## **Proposal for Supplement 9 to the 06 series of amendments to UN Regulation No. 107 (M<sub>2</sub> and M<sub>3</sub> vehicles)**

### **Submitted by the experts from the Working Party on General Safety\***

## Supplement 9 to the 06 series of amendments to UN Regulation No. 107 (M<sub>2</sub> and M<sub>3</sub> vehicles)

"Figure 31

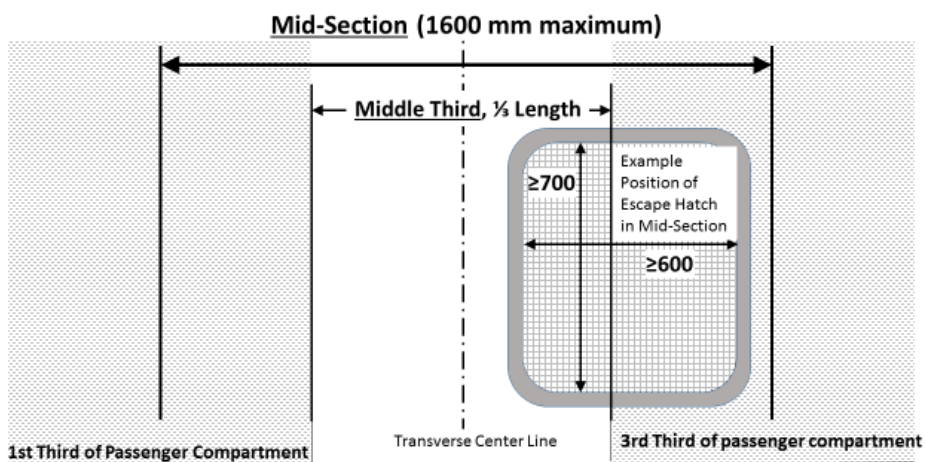
"7.6.2.9. For vehicles of classes A and B, required escape hatches shall be positioned as follows:

- (a) If there is only one hatch, it shall be situated in the middle third of the passenger compartment. As an alternative, on vehicles with a very short passenger compartment length, the hatch may be located in the mid-section of this compartment, and this mid-section shall be equally spaced longitudinally each side of the transverse centre line of the passenger compartment, with a length of no greater than 1.6m as shown in Annex 4, Figure 31;
- (b) If there are two hatches, they shall be separated by a distance of at least 2 m measured between the nearest edges of the apertures in a line parallel to the longitudinal axis of the vehicle."

Annex 4 after Figure 30 insert:

### Alternative placement of escape hatch for very short passenger compartment length having a middle third smaller than 1600 mm

(See Annex 3, paragraph 7.6.2.9.)
